# Historic Preservation Board File No. 25-0676

## 2201 Collins Avenue

UPDATED Presentation by Law Offices of Kent Harrison Robbins, P.A.  
on behalf of the Roney Palace Condominium Association, Inc.

April 14, 2026

# THE PROPOSED ORDER IS INCOMPLETE

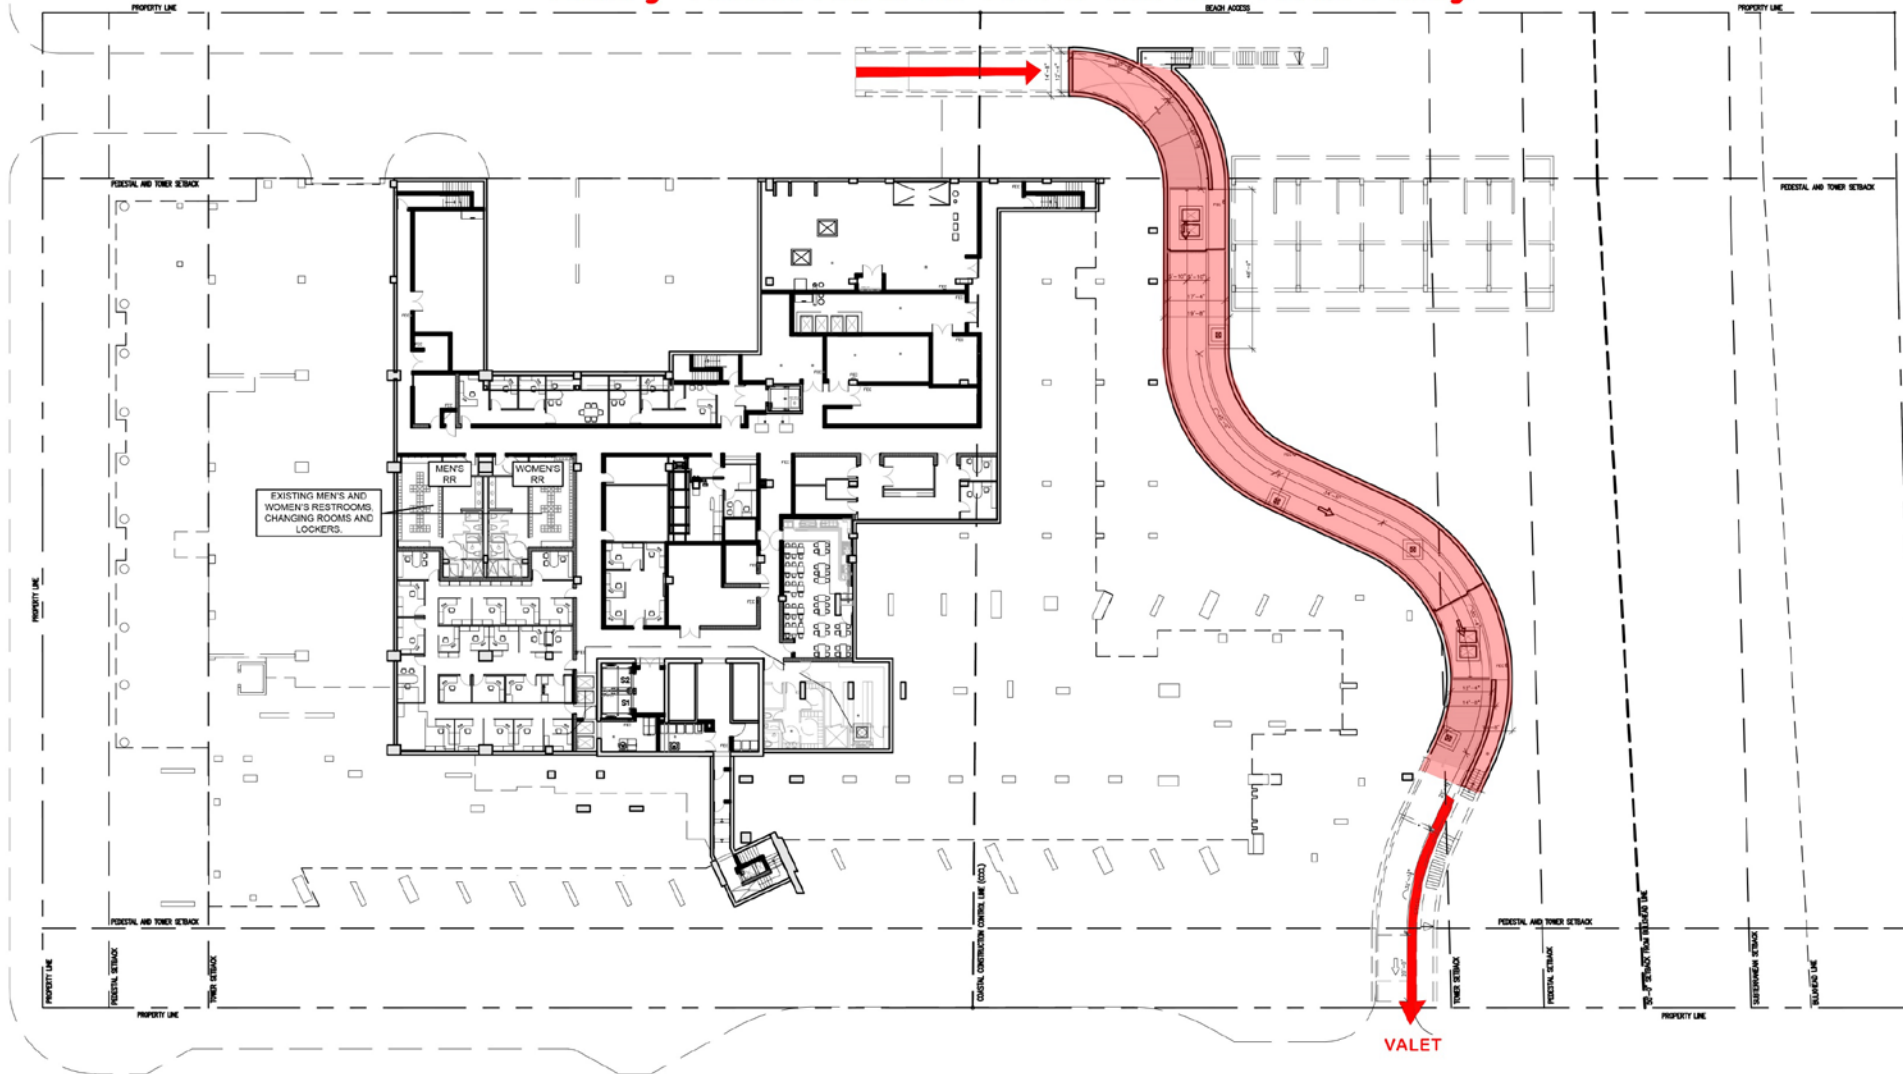
The proposed Order omitted to require the Planning Board to address two critical items:

The proposed new valet stand on the North Driveway (23rd Street)

Guest and ride-sharing vehicle access to the North Driveway for drop-offs

**THE RONEY REQUESTS THE HISTORIC PRESERVATION BOARD ADD TO CONDITION 2 OF THE ORDER:**

*“The Planning Board shall also consider and impose conditions governing: (a) the proposed new valet stand on the North Driveway; and (b) guest and ride-sharing vehicle access to the North Driveway for drop-offs.”*

# VALET TUNNEL Entry West End of 23rd Street Driveway

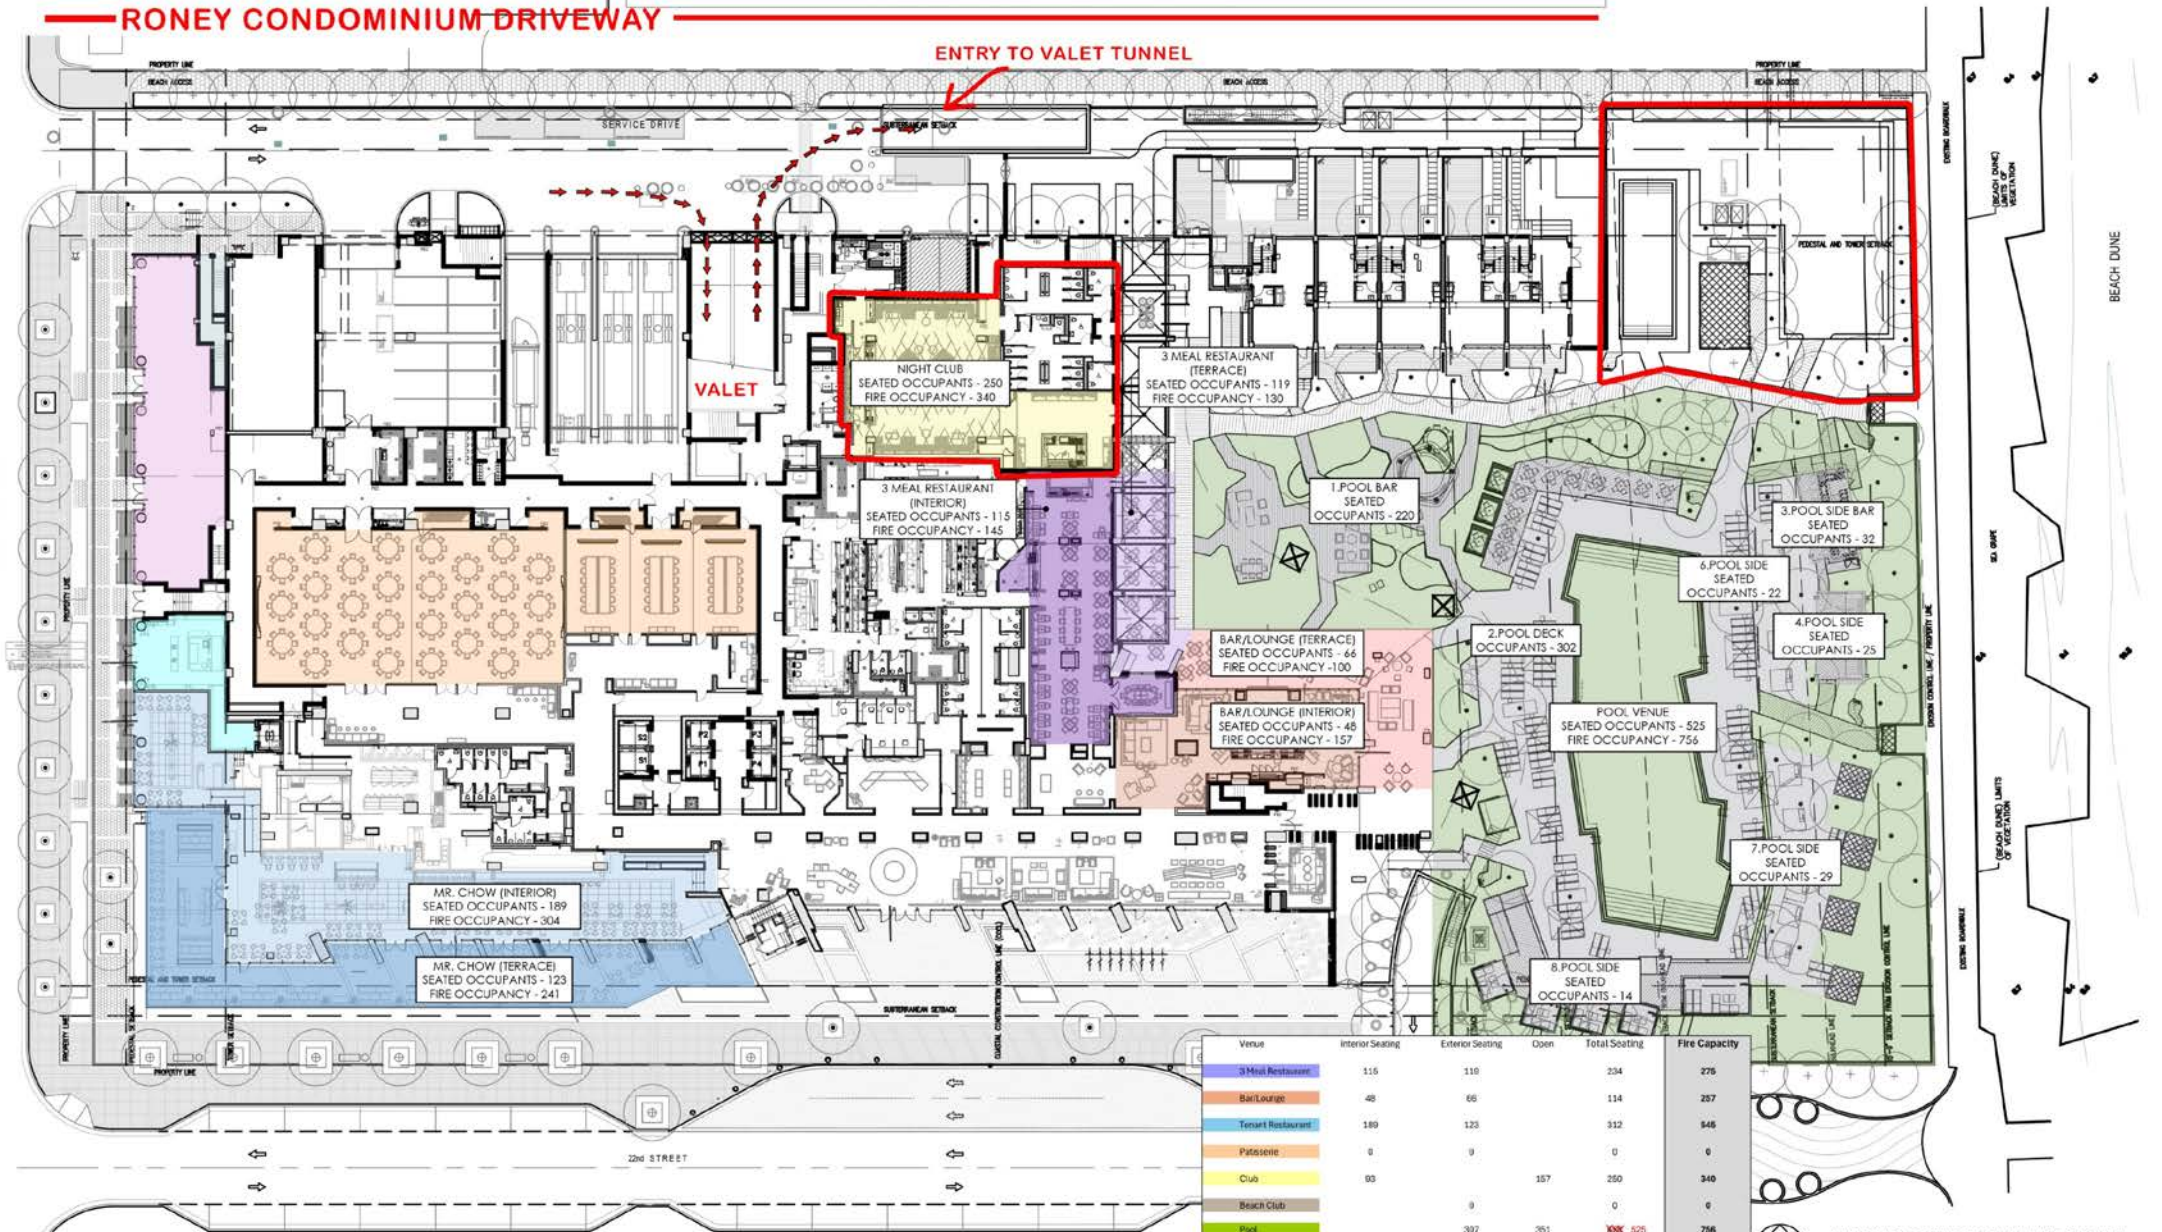
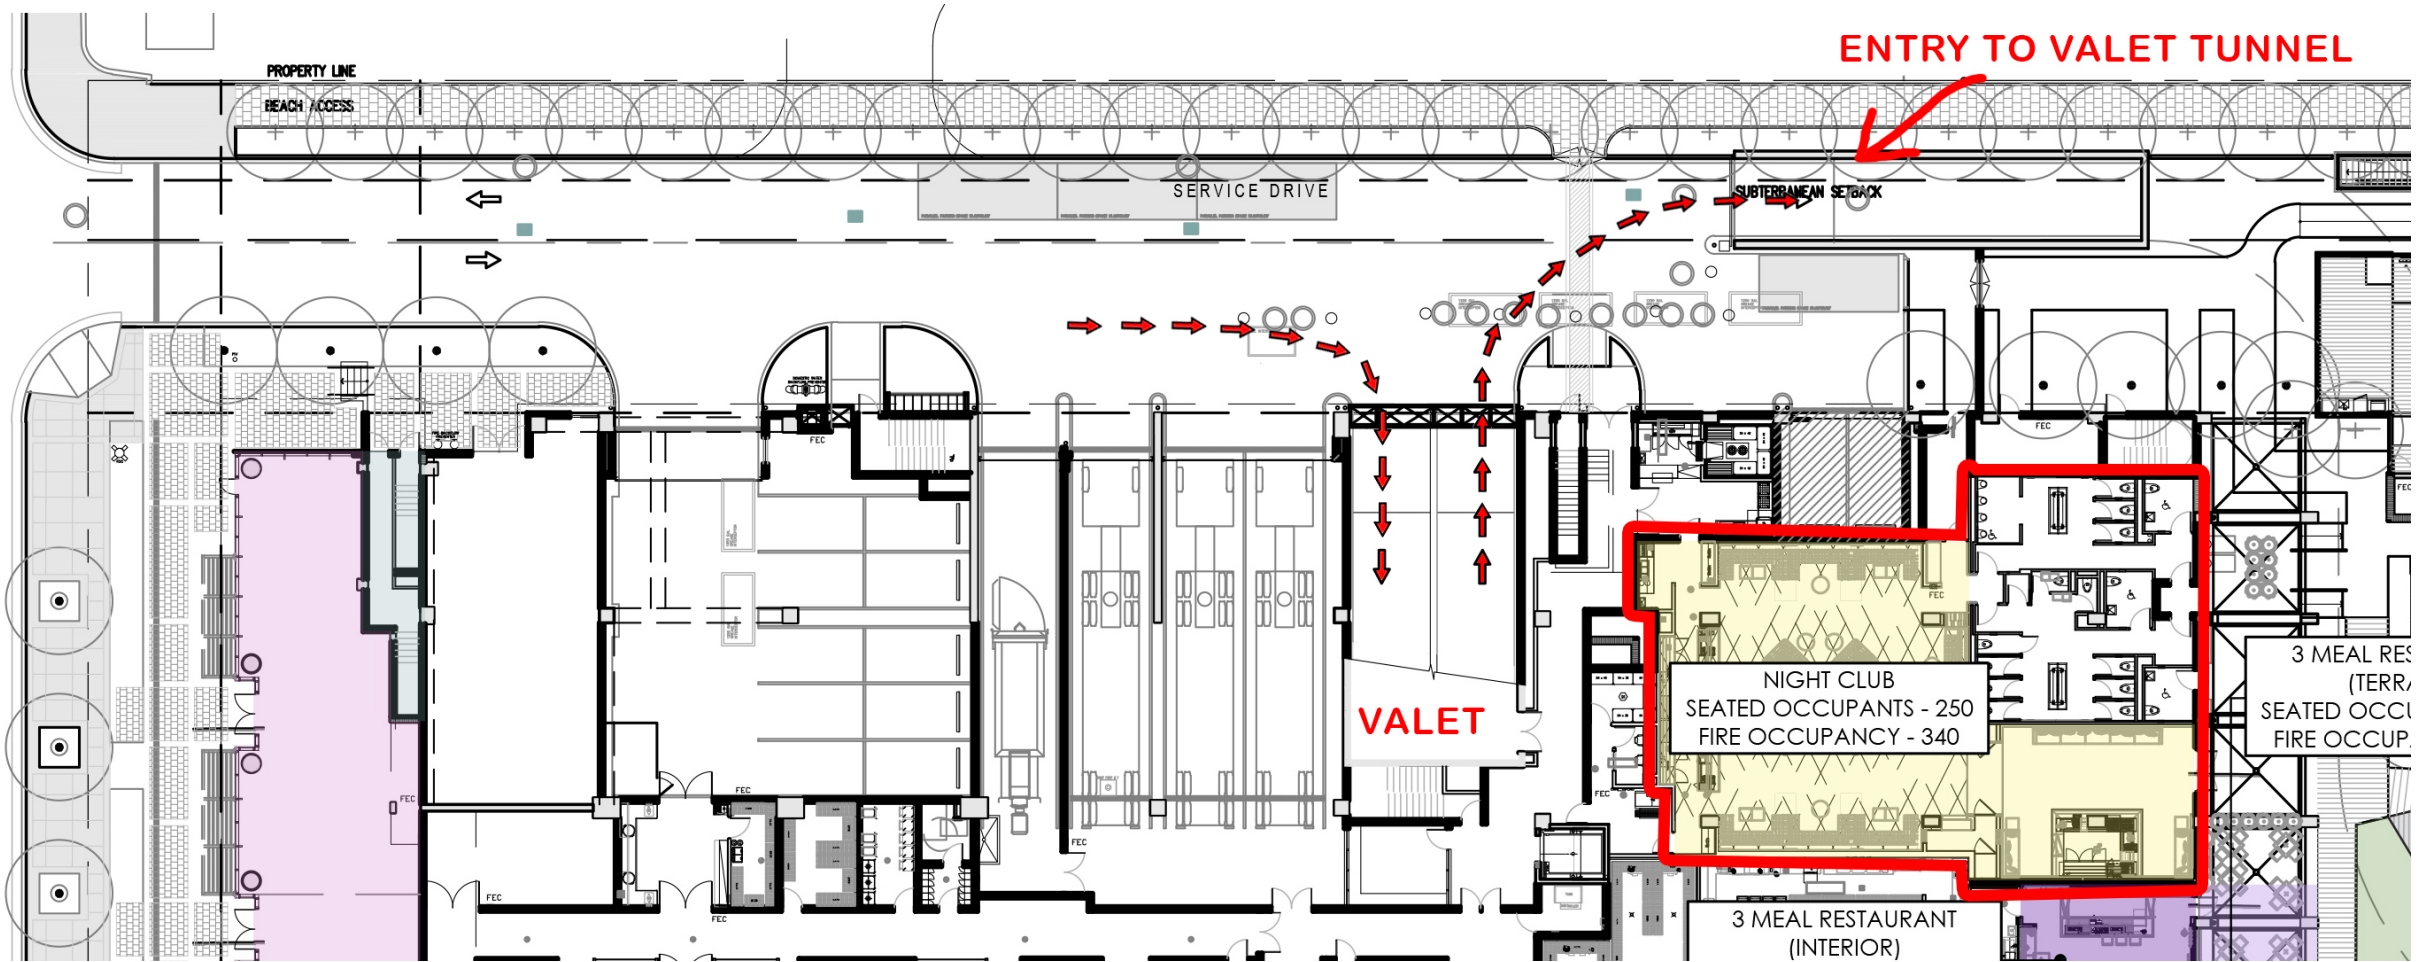
**New Valet Stand on 23<sup>rd</sup> Street Driveway**
